HANNAH RIDGE AT FEATHERGRASS FILING NO. 5

CONSTRUCTION PLANS

HANNAH RIDGE AT FEATHERGRASS FILING NO. 5, 6 & 7 OVERLOT GRADING AND EROSION CONTROL PLAN			
DESIGNED BY	KRC	SCALE	DATE 10/12/18
DRAWN BY	KC	(H) 1" = 50'	SHEET 3 OF 11
CHECKED BY		(V) 1" = NA	JOB NO. 1116.05

NO.	REVISION	DATE																										
DESIGNED BY	KRC	SCALE	DATE																									
DRAWN BY	KC	(H) 1" = 50'	10/12/18																									
CHECKED BY	(V) 1" = NA	SHEET 2 OF 11	JOB NO. 1116.05

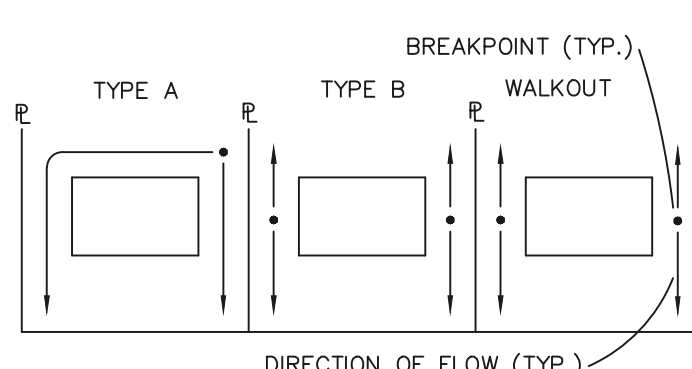
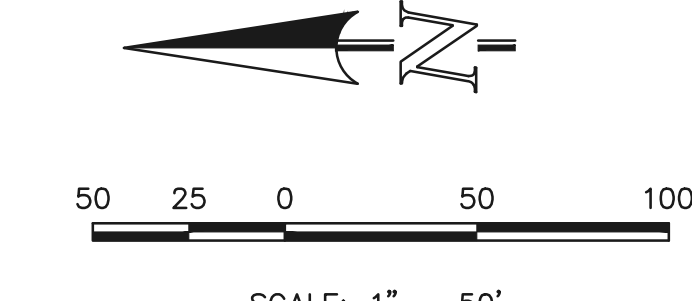
Provide typical roadway sections.

Use EPC Optional Type C C&G for Type C

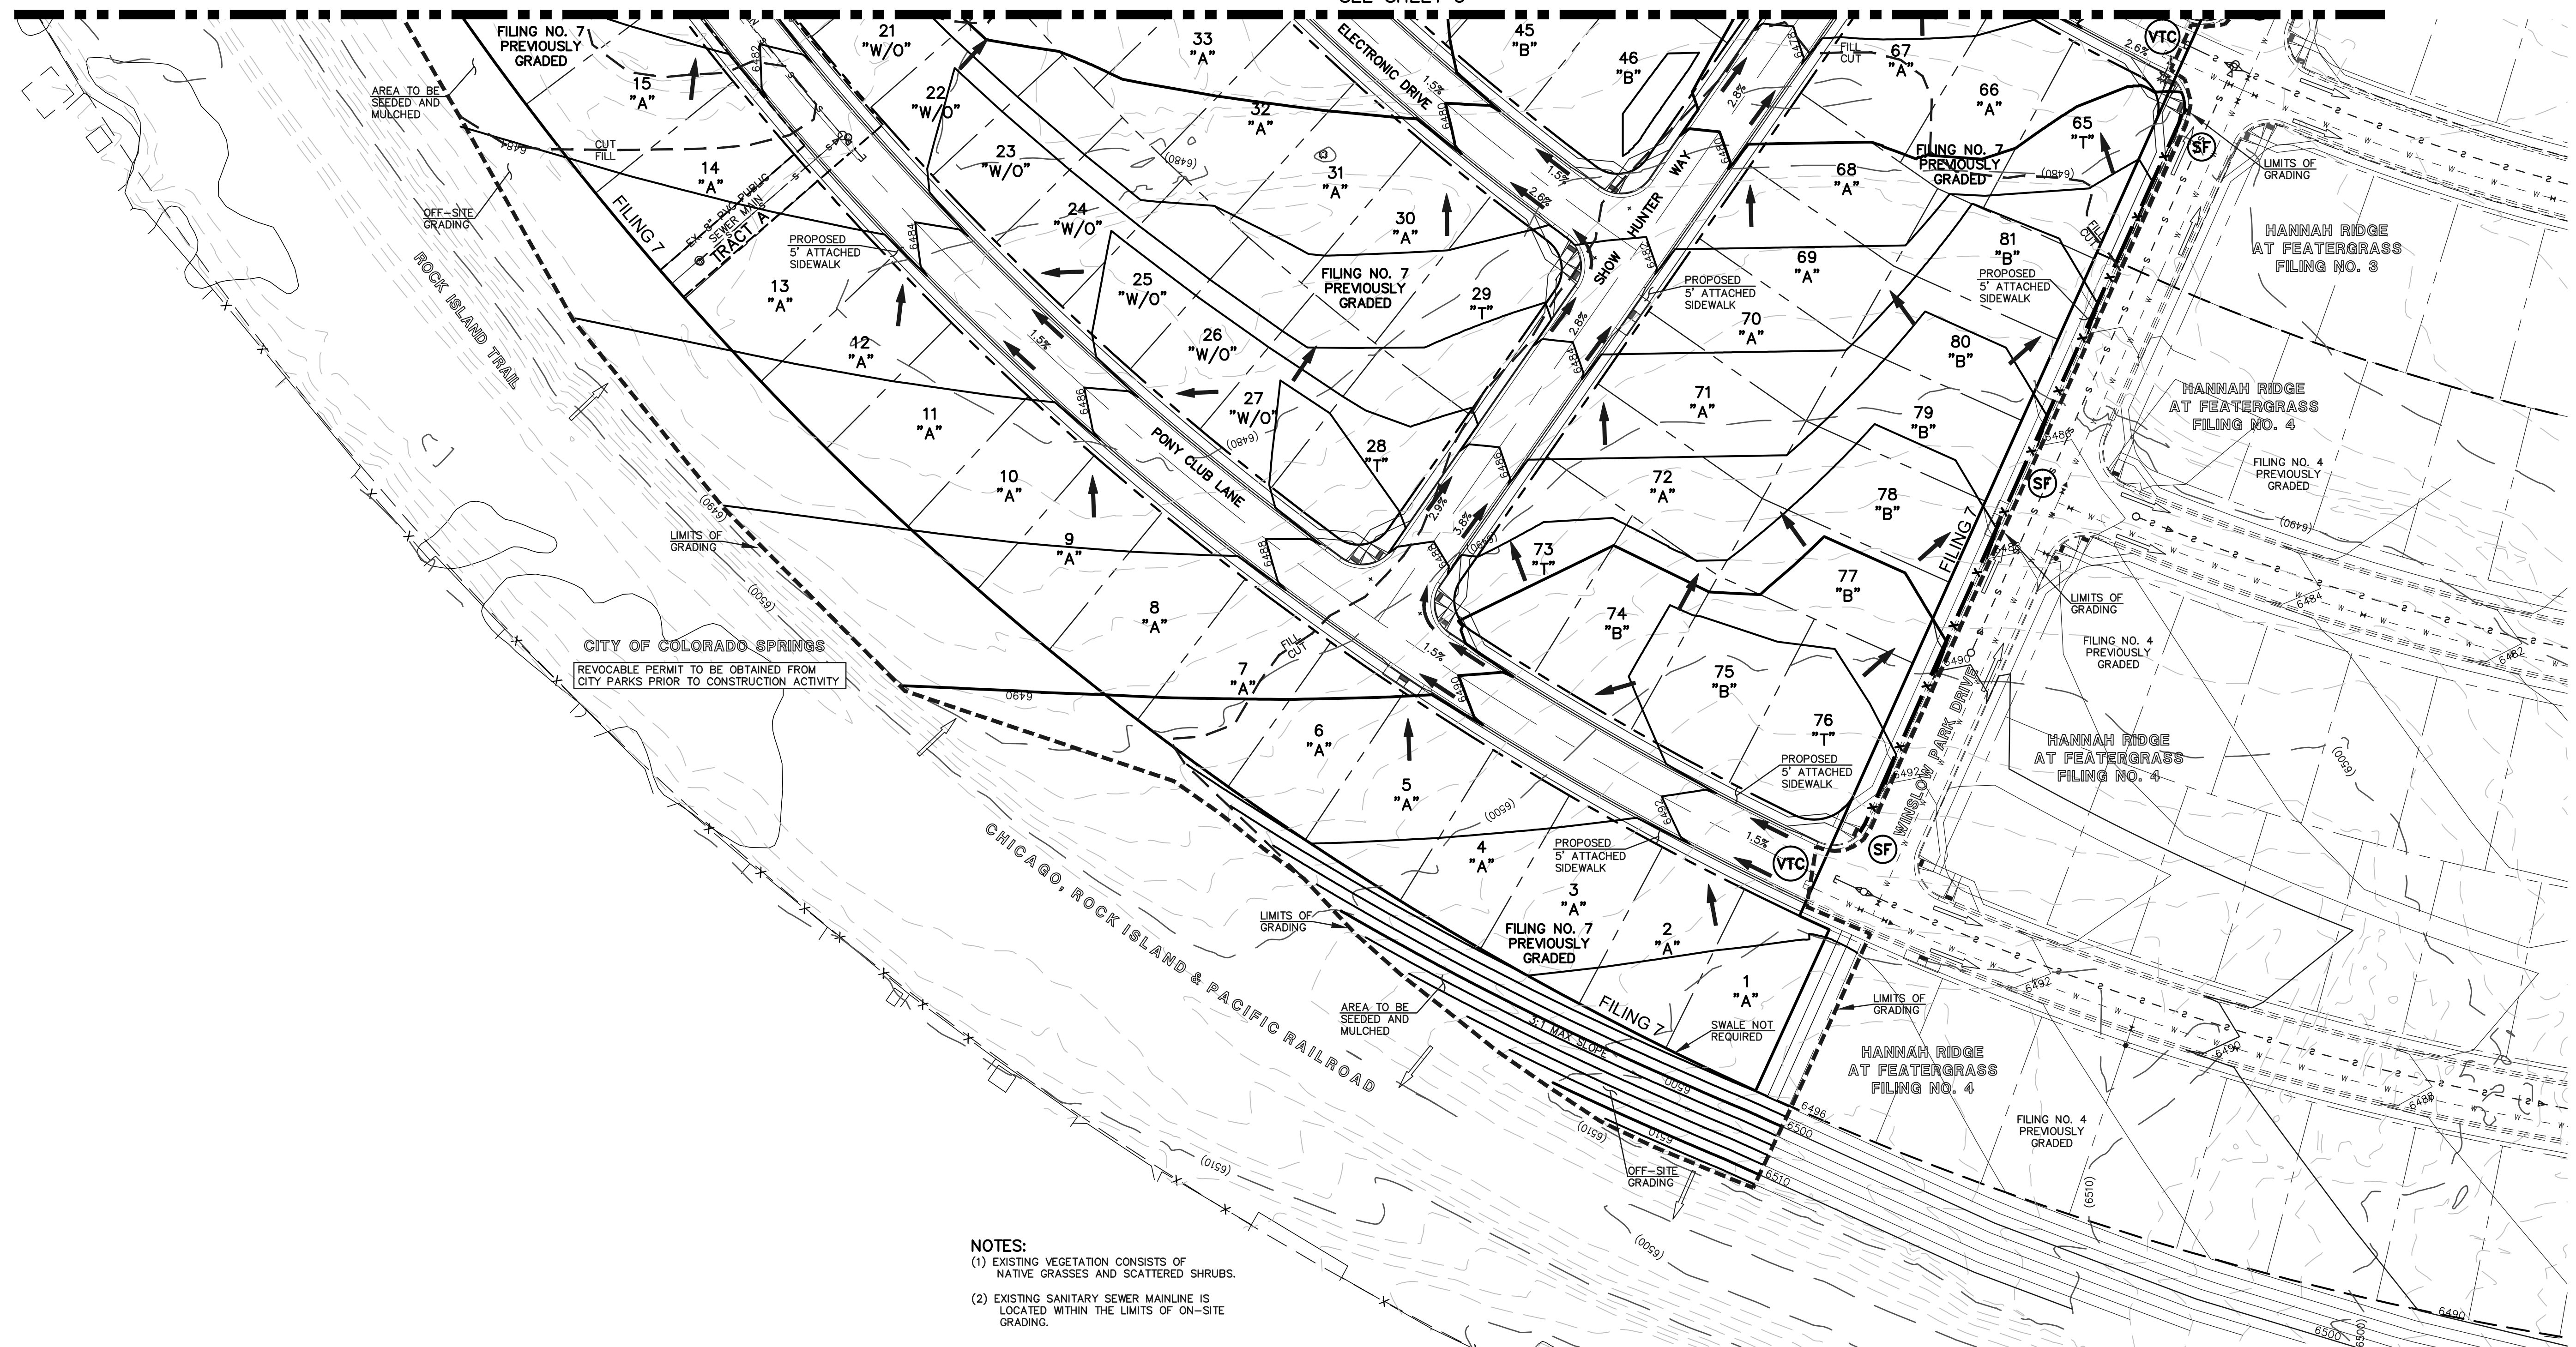
There is generally an insufficient amount of sediment control shown on this plan. For example:
 There is only one TSB where they are recommended in the criteria to be placed for roughly one acre areas.
 There is no concrete wash out shown.
 There is no provisions for, or ditch checks provided to stop erosion where the curb and gutter will be constructed.
 There are several areas (back yards, etc) where silt fence should be shown.

HANNAH RIDGE AT FEATHERGRASS
 FILING NO. 5
 STREET IMPROVEMENT PLANS
 EQUINE COURT

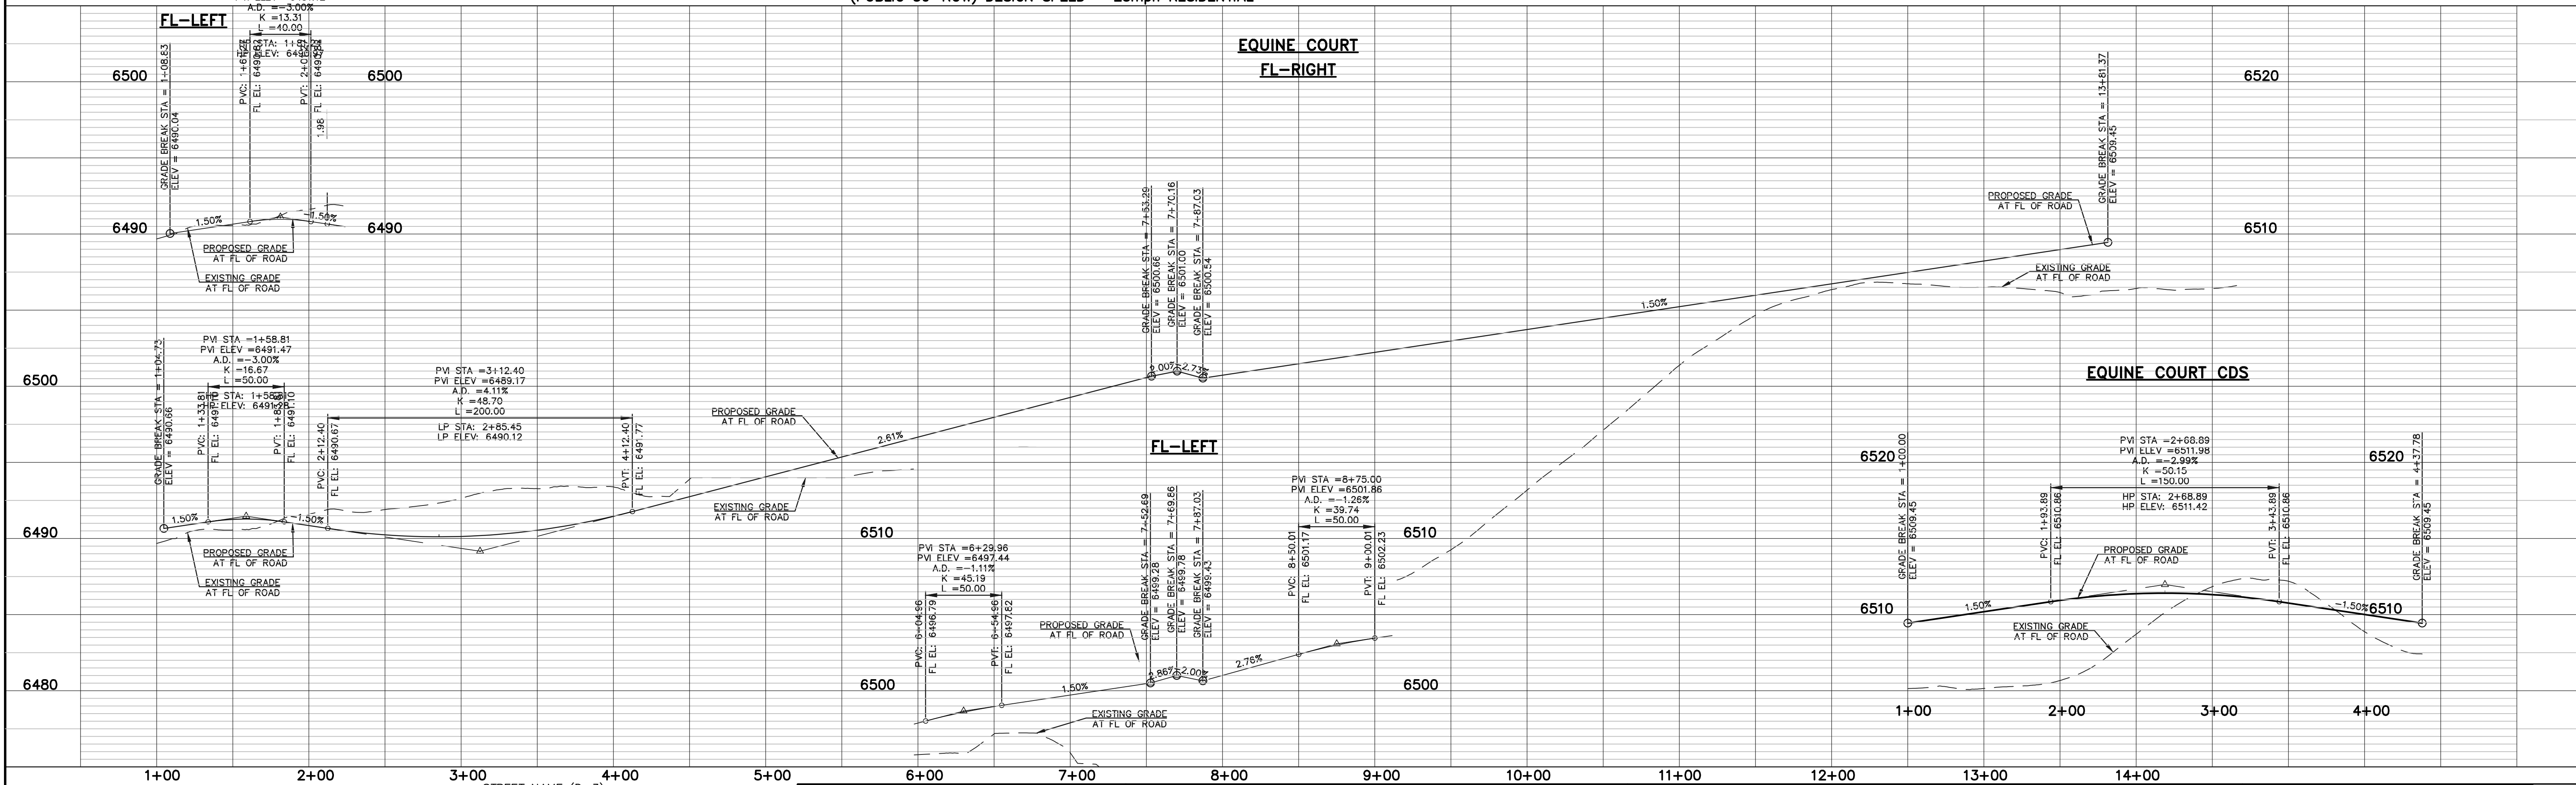
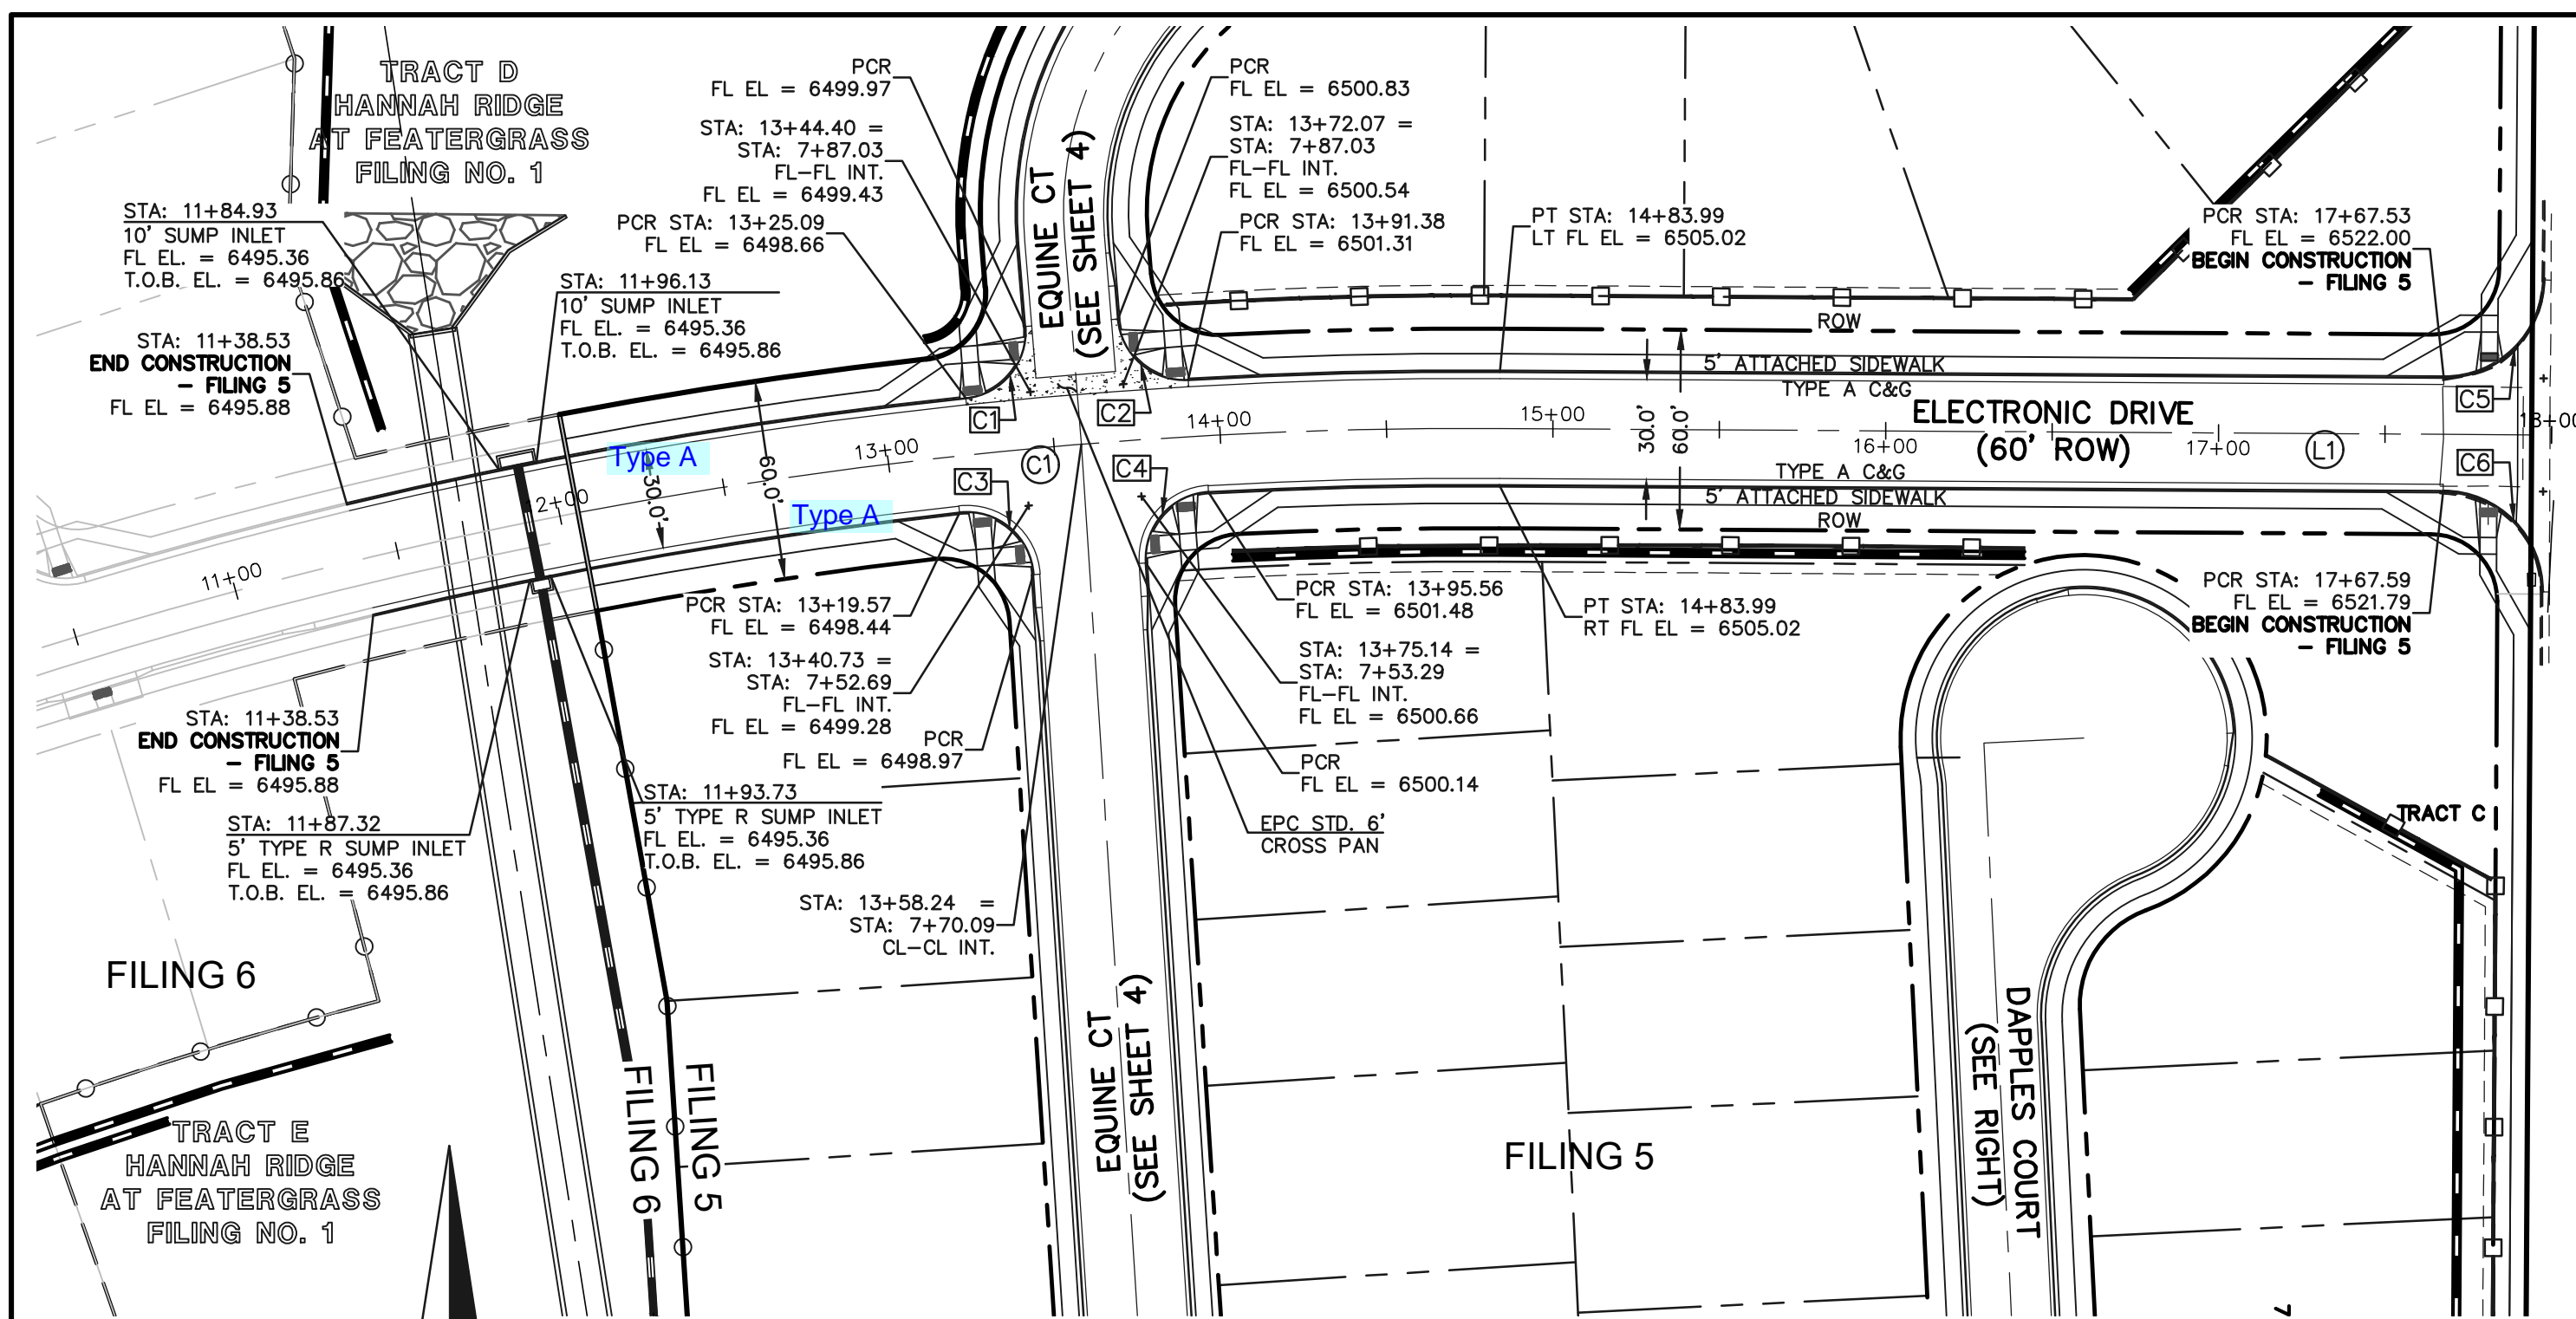
Provide Signing and Striping Plans for all three filings.
